#01-06-04-011: Technical - Water in AIR Pump and/or DTC P0410, P0412, P0415, P0416, P0100, P0101, P0102 or DTC 48 (AIR System Disable Procedure) - (Feb 23, 2001)

Models: 1995-1996 Buick Roadmaster
1995-1996 Cadillac Fleetwood
1995-1996 Chevrolet Caprice, Impala SS
with 4.3L or 5.7L Engine (VINs W, P -- RPOs L99, LT1)

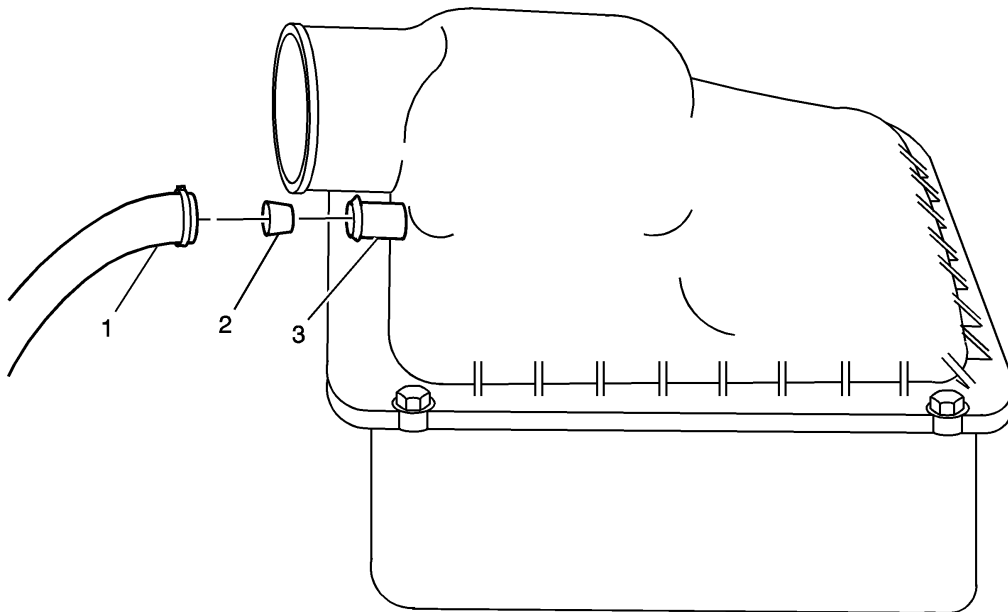
- Locate the relay center (1) and air cleaner box (2).

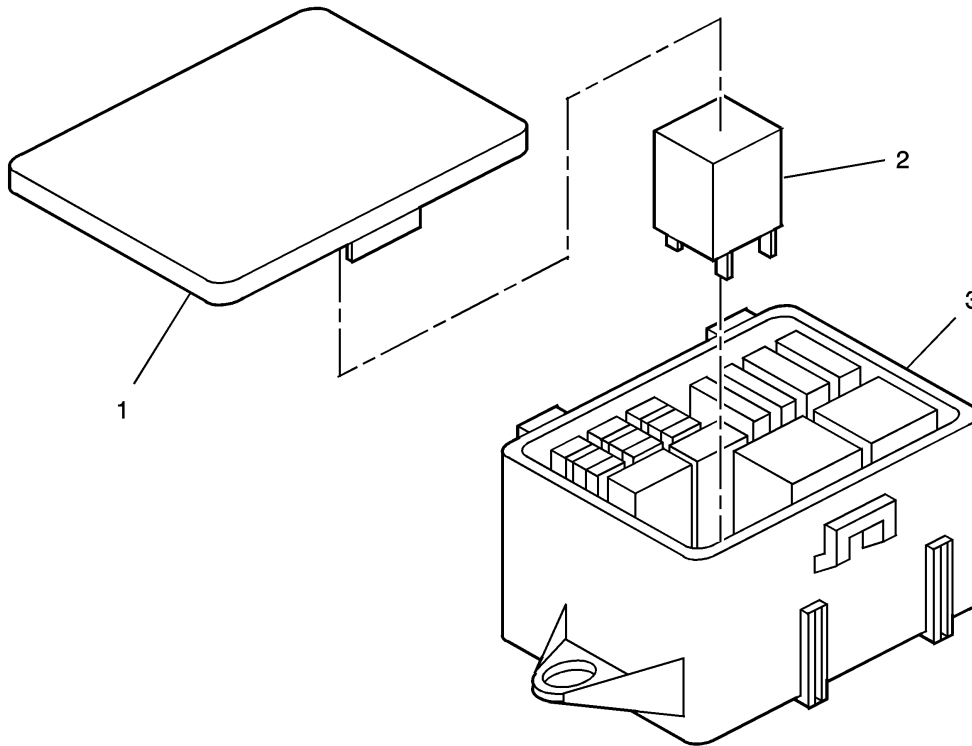
- Remove the AIR hose and clamp (1) from the air cleaner box.
- Insert the plug (2) into the air cleaner box AIR hose inlet (3).
- Install the AIR hose and clamp (1) to the air cleaner box.

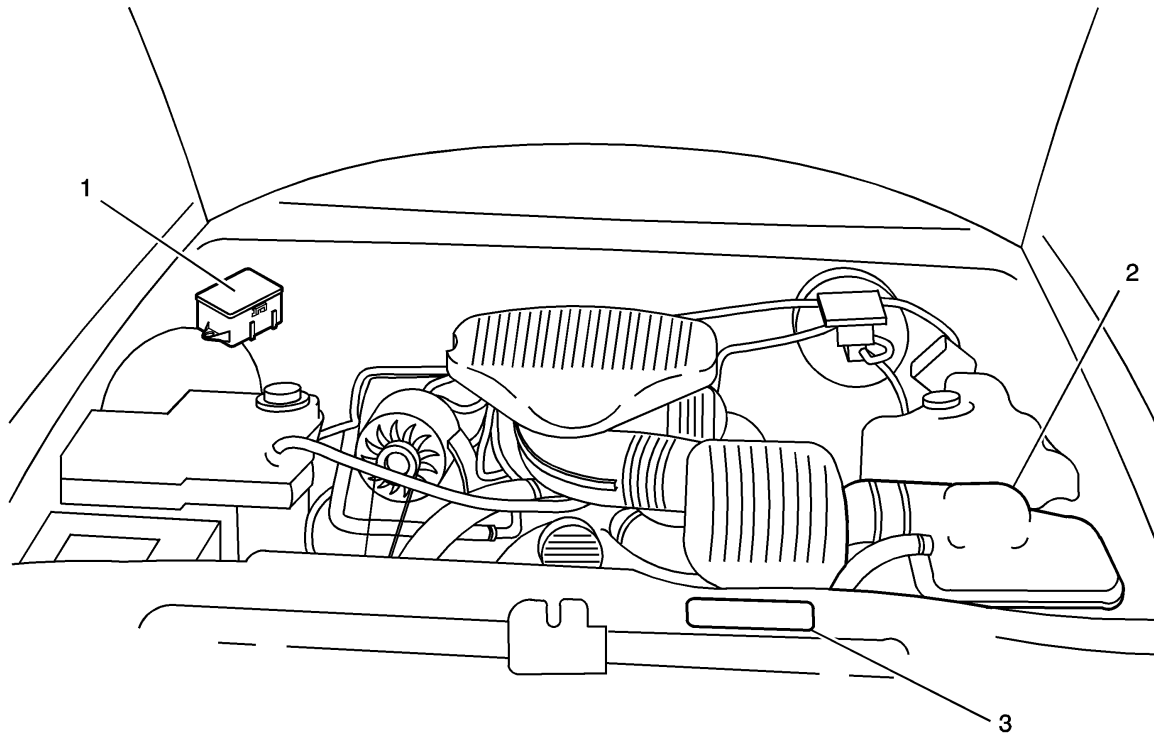
- Remove the cover (1) from the relay center (3).
- Remove AIR pump relay (2) from the relay center (3).
- Install the relay cover (1).

- Install new emission label to radiator support (3).
- Update vehicle calibration. (1995 4.3 L L99 Caprice, and 1996 vehicles)
